AUTOMATIC TRANSMISSION SERVICE GROUP

SEMINARS '88

TECHNICAL INFORMATION PACKAGE

Figure 1

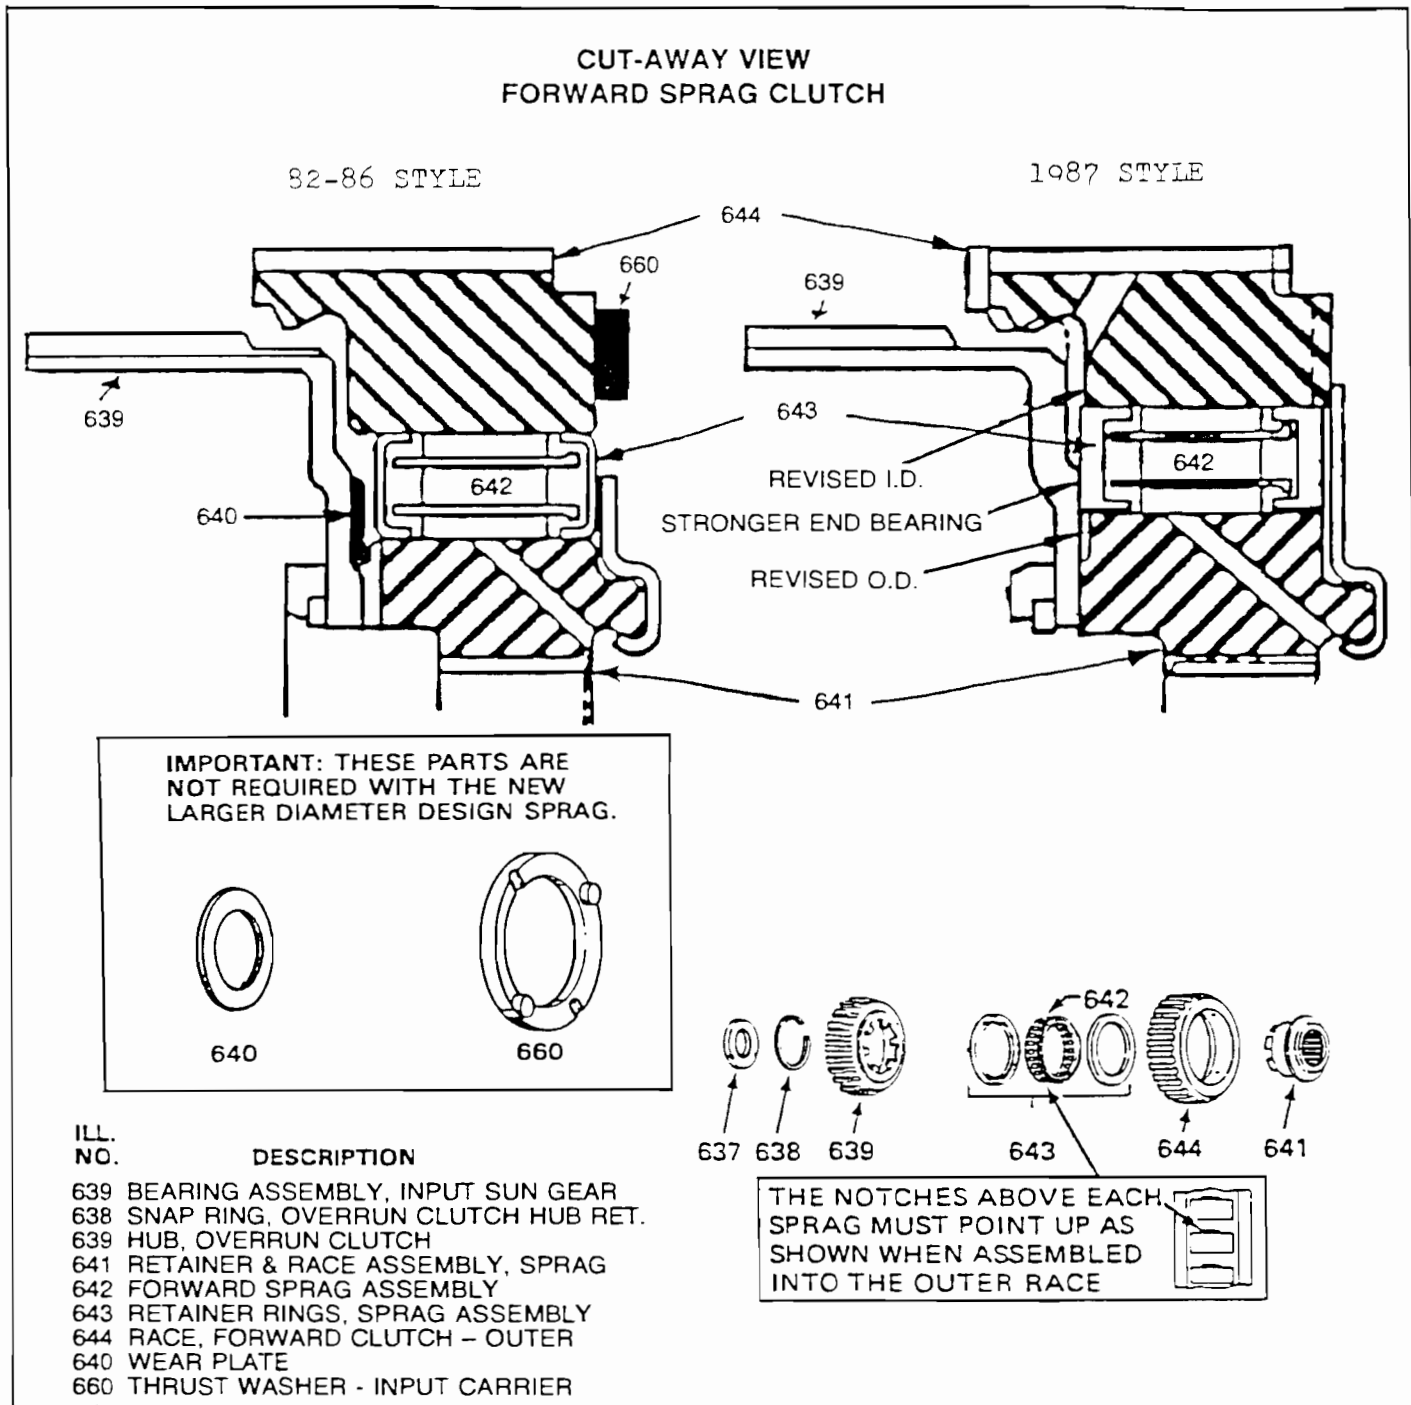
There are two additional sprag elements (This increased elements from 26 to 28), and revised diameters on the inner and outer races, along with solid steel end bearings (See Figure 1 for comparison).

When the new design sprag is used, the wear plate and the black plastic input carrier thrust washer are eliminated (See Inset Fig. 1). The wear plate (640) is eliminated to make room for the solid steel end bearings, and the long lip of the retainer on the sprag inner race takes the place of the input carrier thrust washer (660). See Figure 1.

Use of the input carrier thrust washer (660) with the new design sprag assembly will cause a misbuild (Correct end clearance cannot be obtained).

Figure 1

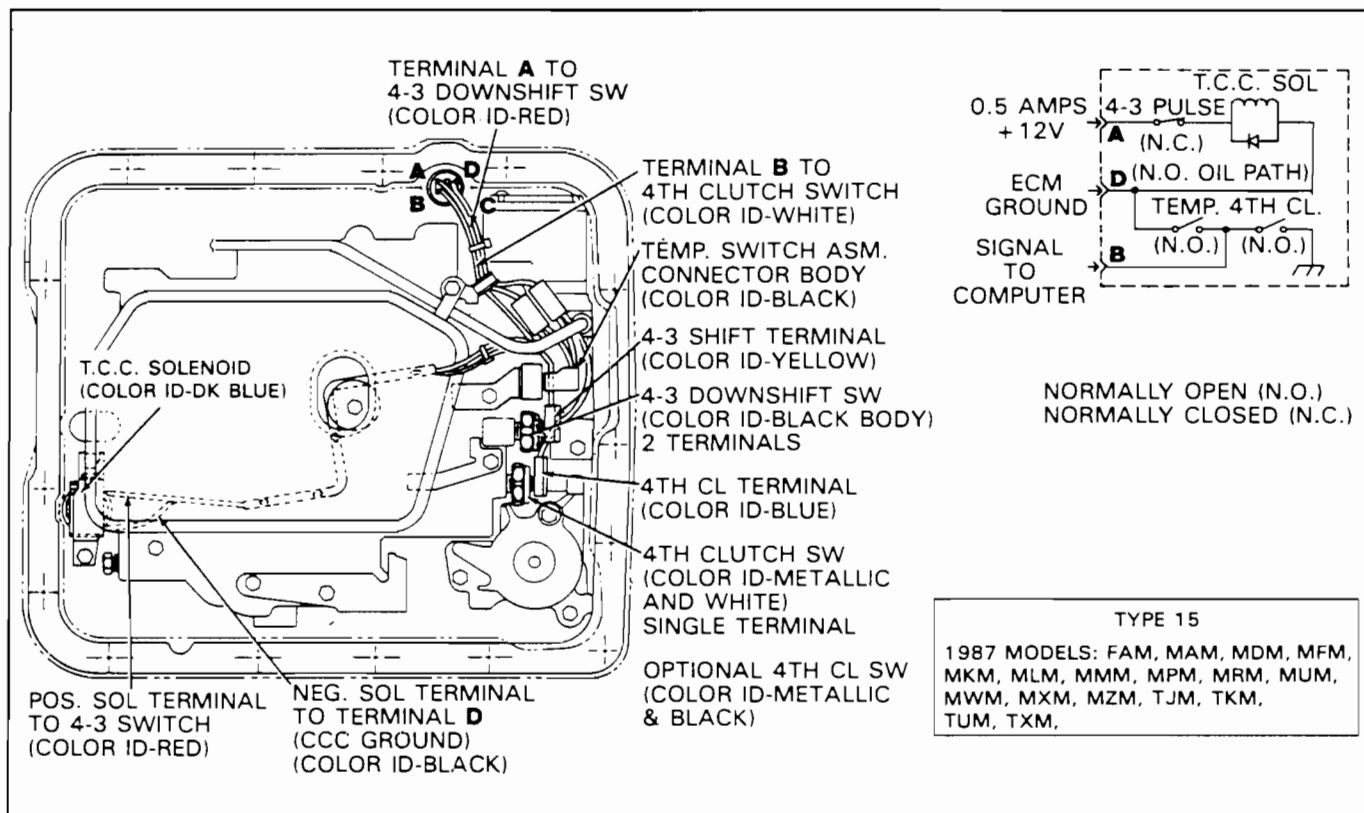
Beginning July 17, 1986, Julian Date 198, for 1987 THM 700-R4 transmissions, a new solenoid and wiring harness (Type 15) went into production, along with a new temperature switch and bracket assembly (See Figure 1).

Figure 1

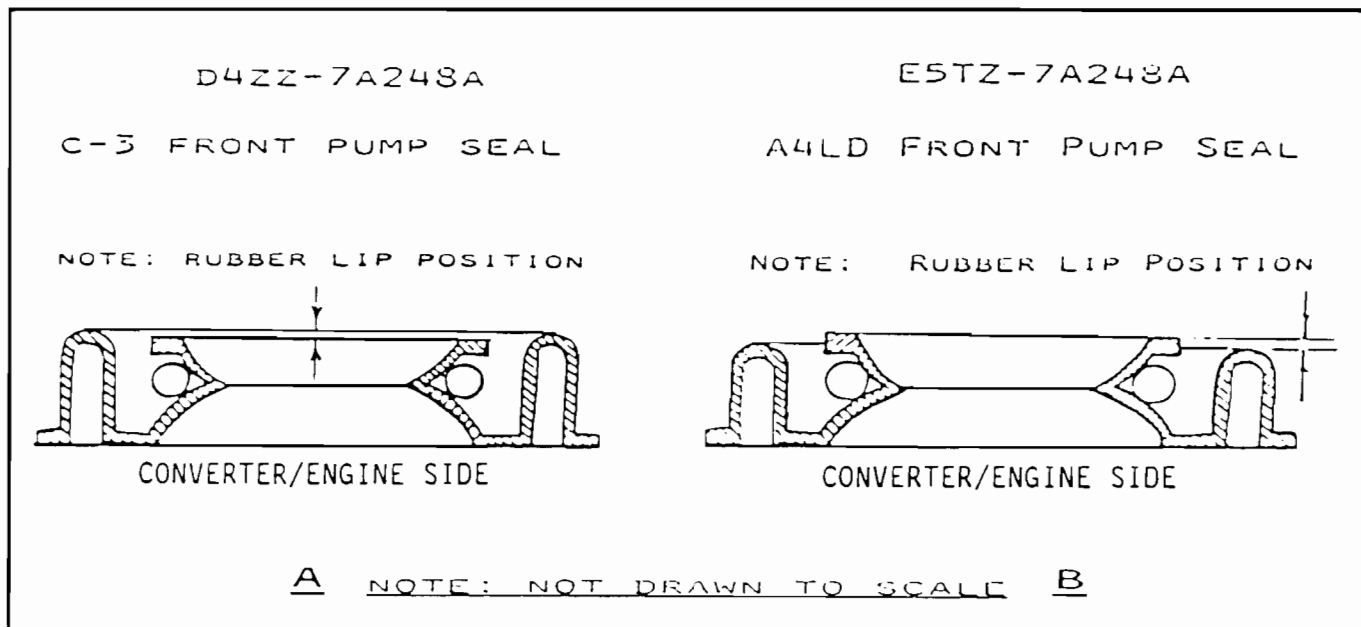
- COMPLAINT: C-3 front seal pops out after overhaul or seal replacement.
- CAUSE: One cause can be the use of an A4LD front seal used in place of the C-3 front seal. See Figure 1 B (A4LD seal). Note that the lip of the seal protrudes past the metal base of the seal housing. When the seal is installed, the rubber portion of the seal restricts the drain passage behind the seal. In Figure 1 A (C-3 seal), the seal lip is below the metal base of the seal.
- CORRECTION: Install a C-3 front seal (D4ZZ-7A248A) in C-3 transmissions.

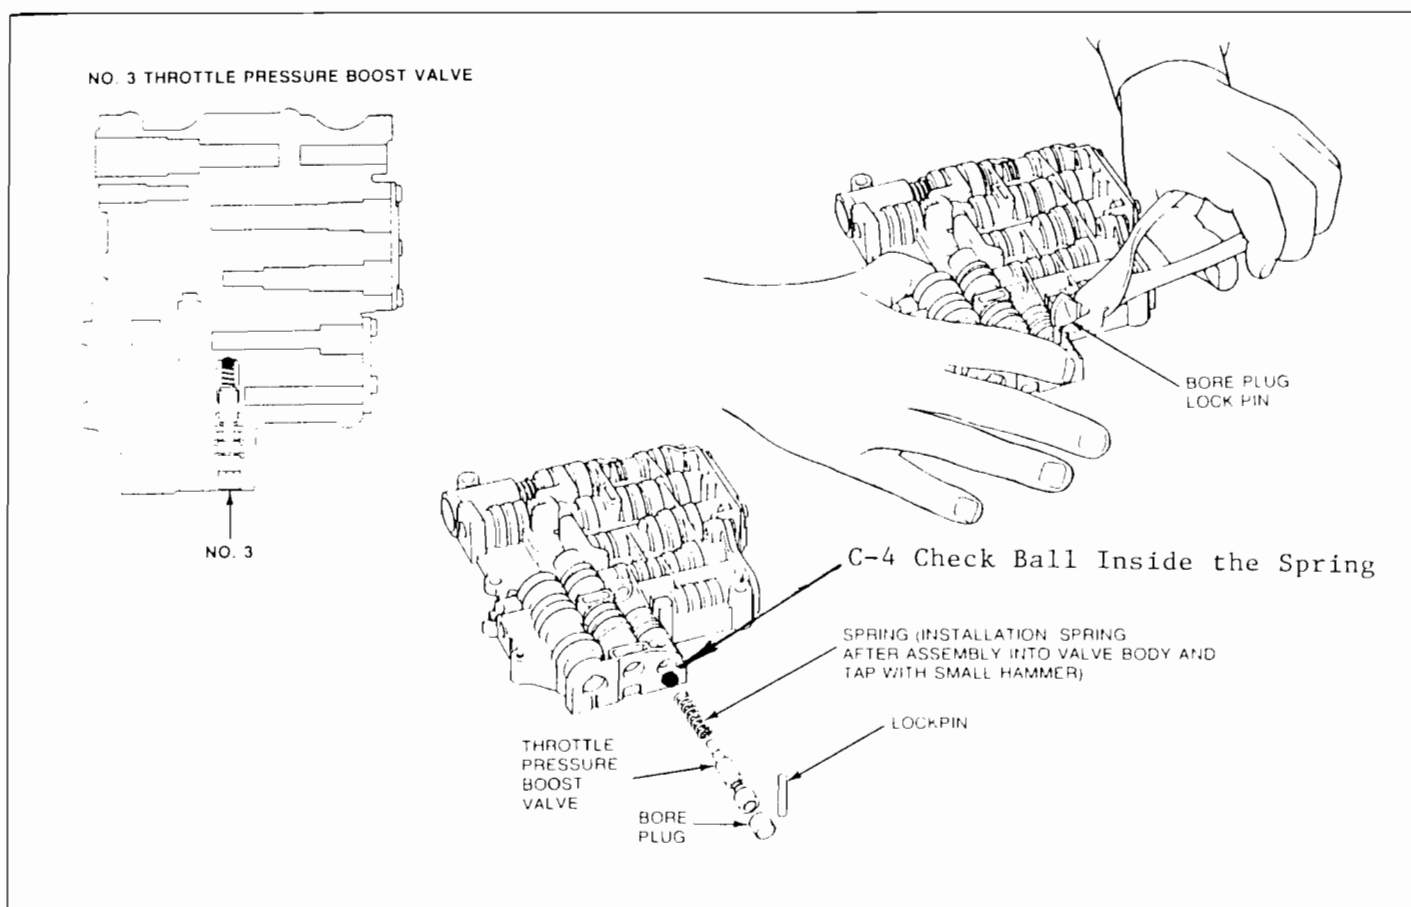
On the Ford C-4 transmission, you may get a complaint of sensitive part throttle downshifts, which means that when you are driving in third gear and you barely touch the throttle, the unit will downshift to second gear.

If you know that all of the above are correct, you can block the throttle booster valve by using a C-4 check ball inside the spring as shown below.

Figure 8 — Article No. 85-11-9

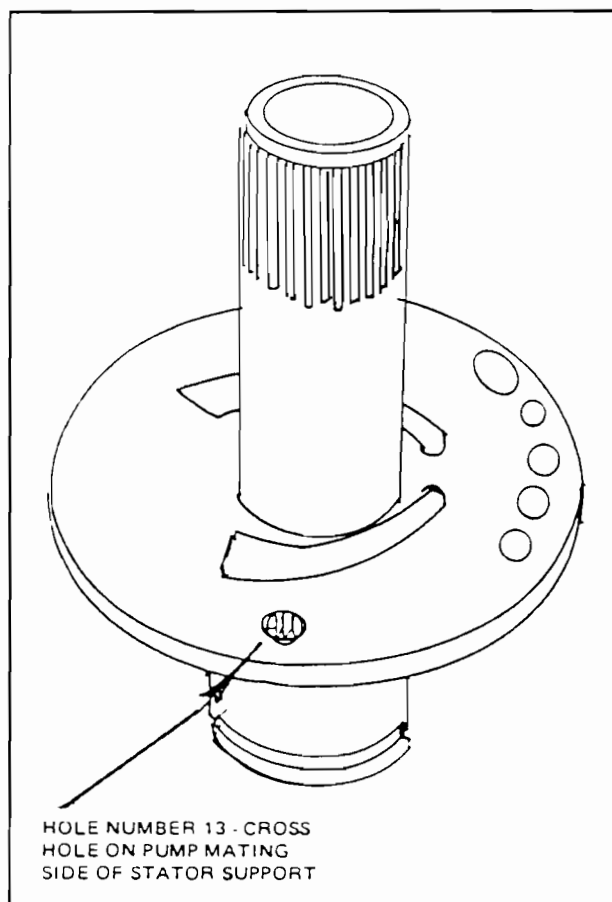
When overhauling a low mileage AOD transmission with evidence of overheating, inspect the converter drainback cross hole passage in the pump stator support for contamination, or a spring compressed solid which would indicate a stuck open check ball. (See Figure 8, Hole No. 13.)

The converter drainback valve in Hole No. 12 of the pump stator support consists of a spring and a ball with an aluminum ball plug pressed in the passage. If contamination can be seen in the exposed cross hole passage area or if the spring is compressed solid which would indicate a stuck open check ball (can be seen when the stator support is turned over — refer to Figure 8, Hole No. 13), then follow the procedure included here for removal and cleaning of the converter drainback valve. In addition, the converter will have to be replaced.

1. To remove the drainback valve (check ball and spring) in Hole No. 12, remove the aluminum ball plug. This can be done by using a suitable punch inserted into the cross Hole No. 13. (See Figure 8.) Discard the aluminum ball plug and the spring. The check ball must be retained for reinstallation.

2. Flush and clean the passage.
3. Install the check ball and a new spring. Press in flush a new aluminum ball plug as indicated in Figure 10.
4. Reassemble the pump body and stator support assembly according to the procedure in the appropriate model year Shop Manual.
5. Install a new torque converter.

Figure 2

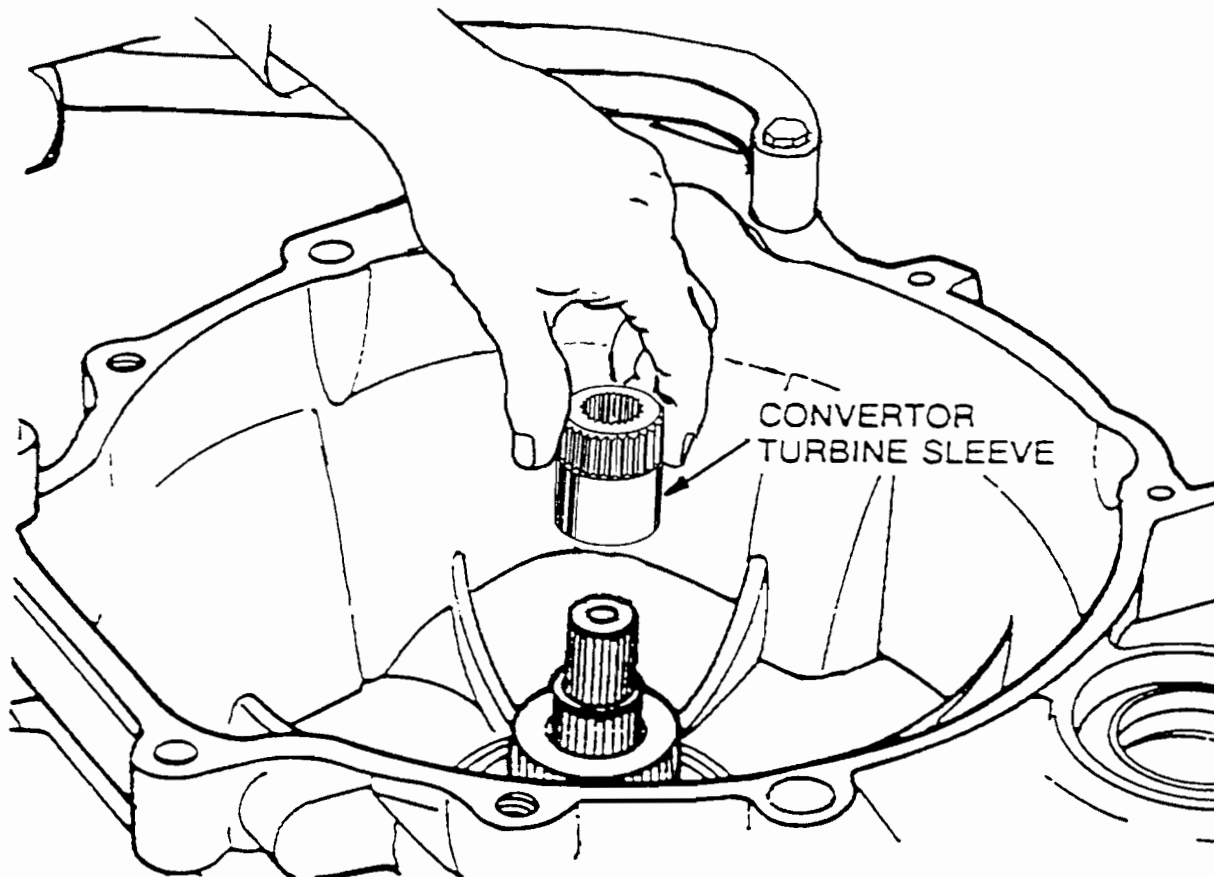
1987-88 Tempo Topaz only use a converter adapter sleeve, Part Number E7FZ-7A878-A. This sleeve has two internal splines and one external spline. (See Figure 1) Since this is a slip on adapter, it can stay engaged in the torque converter turbine hub upon removal of the converter from the transmission. If this adapter IS NOT reinstalled on the transmission (turbine and intermediate shafts), a NO DRIVE CONDITION WILL BE THE COMPLAINT AFTER INSTALLATION. (See Figure 2)

Figure 21

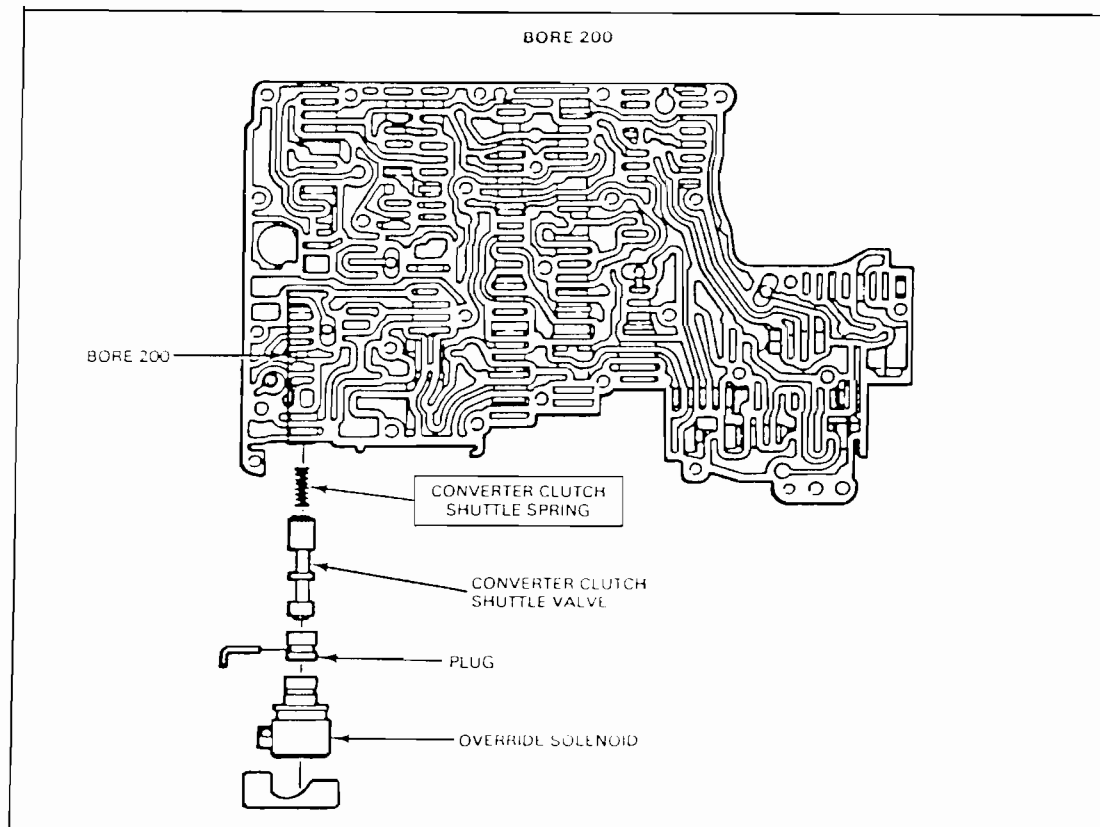
Refer to the valve body identification illustration in Section 17-08 of the Shop Manual or Figure 21, for the shuttle valve bore location (bore reference number 200). Locate the converter clutch shuttle valve spring. See Figure 21.

Remove the retainer plate, override solenoid, plug, valve and spring. Remove any foreign material from the bore. Do not dislodge the shuttle balls.

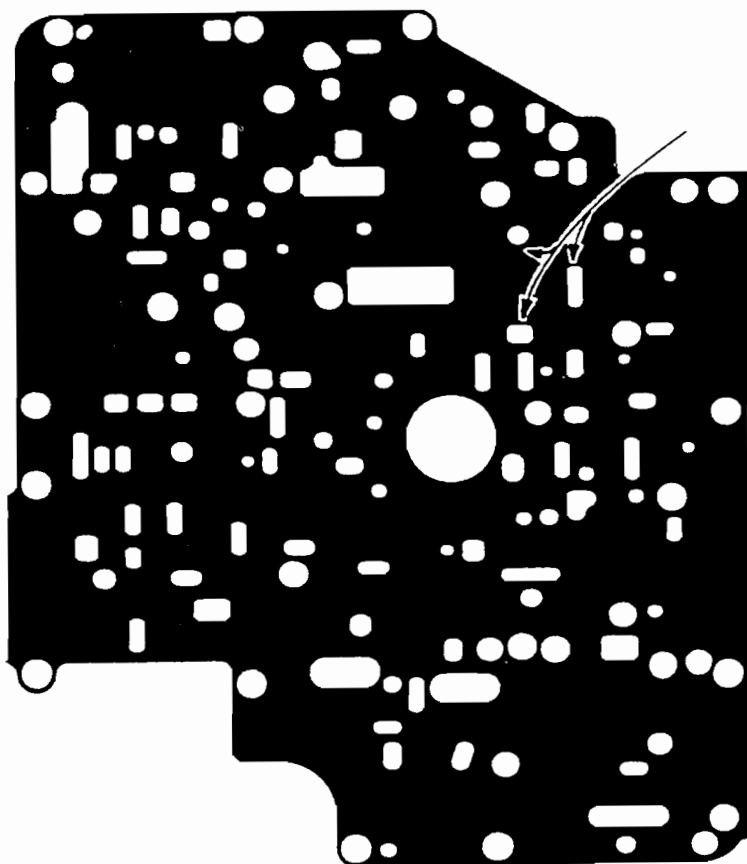
NOTE: THESE THREE HOLES
ADDED TO THE 1987 GASKET

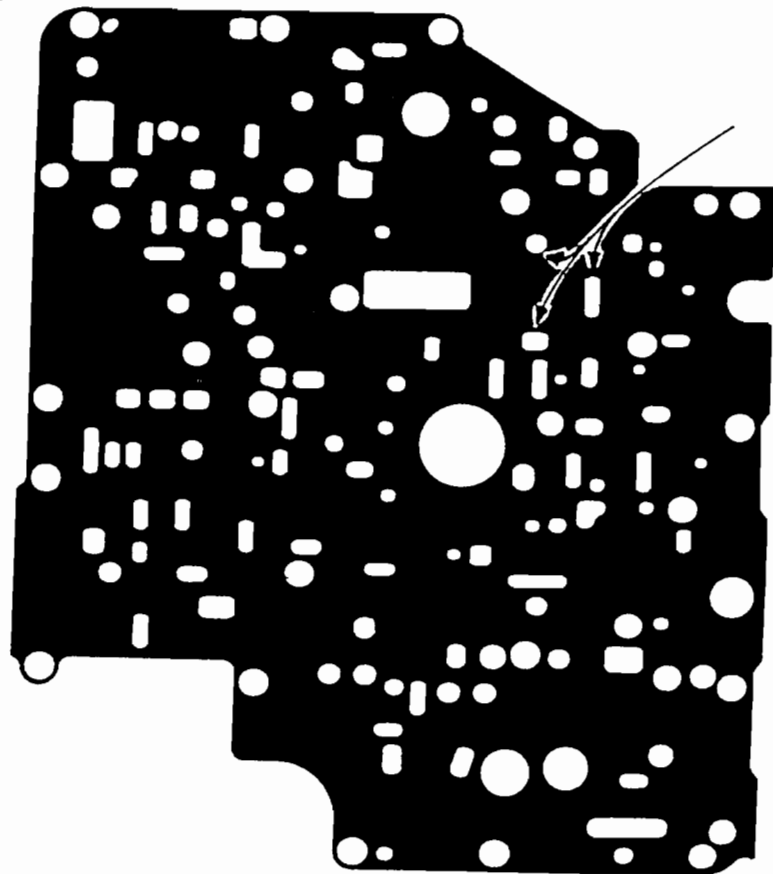
NOTE: THESE THREE HOLES
ADDED TO THE 1987 GASKET
